Product Change Notification - SYST-09HZSA980

ERRATA - PIC32MZ Embedded Connectivity with Floating Point Unit (EF) Family Silicon Errat

PIC32MZ Embedded Connectivity with Floating Point Unit (EF) Family Silicon Errata and Data Sheet Clarification

FIGURE 1: Posc CRYSTAL CIRCUIT

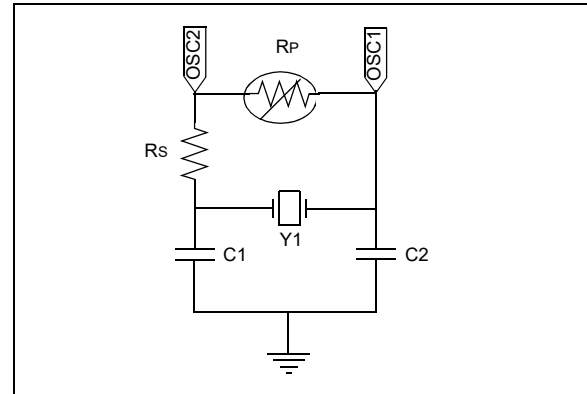
Revision A3 and B2 Silicon: The Posc has been tested in a normal power-up sequence and supports specific crystal operation.

The Primary Oscillator (Posc) has been characterized to operate at 8 MHz, 12 MHz, and 24 MHz when the circuit in [Figure 1](#) is implemented, and the operating conditions listed in [Table 3](#) are met.

Crystal Frequency (see Note 1)	Series Resistor (Rs)	Posc Gain Setting POSGAIN<1:0> (DEVCFG0<20:19>)	Posc Boost Setting POSCBOOST (DEVCFG0<21>)
8 MHz	2 kΩ	'0b00 (GAIN_0)	'0b1 (ON)
12 MHz	1 kΩ	'0b00 (GAIN_0)	'0b1 (ON)
24 MHz	0 kΩ	'0b00 (GAIN_0)	'0b1 (ON)

Note 1: Using any other crystal frequency will require special component selection and characterization.
2: A parallel resistor (Rp) should not be used to increase the gain of the POSC.
